Chuck E Cheese

CONSTRUCTION PERMIT
APPLICATION

CONSTRUCTION PERMIT

Project
 CHUCK E. CHEESE'S
 BRICK PLAZA
 BRICK, NEW JERSEY

Design No. U501
Assembly Rating—3 Hr.

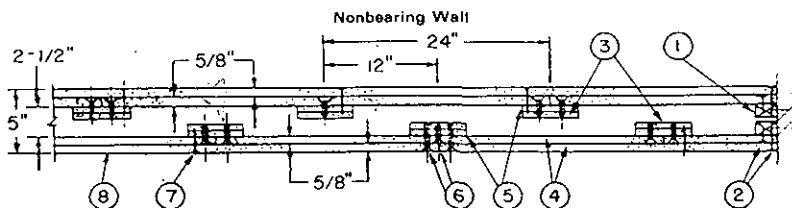
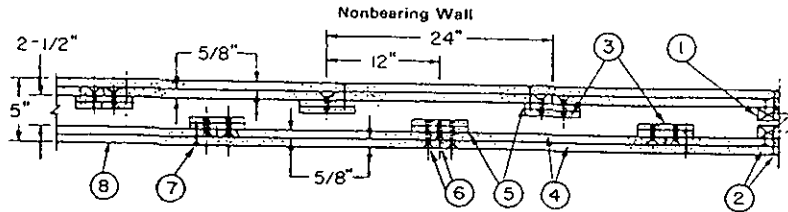
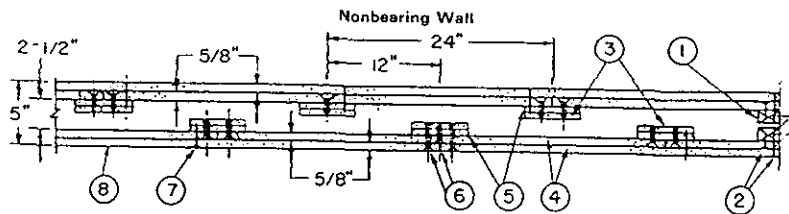
Pursuant to our conversation of 5 October 1992, it is our understanding that we shall be required to provide for a fire wall separating our A-3 occupancy and adjacent tenants in the structure. Per BOCA (1990), we have drawn the following conclusions:

In reference to the above project and our previous correspondence of 24 September 1992 and 6 November 1992, both letters are to be considered in error. It is our understanding, by code, that the requirement is to provide a 2-hour fire wall separating our A-3 occupancy from adjacent tenants in the structure. Per BOCA (1990), we have drawn the following conclusions:

Having received and reviewed your response, dated 9 November 1992, to our request for reduction in the rating of the fire wall in question on this project, we offer the following:
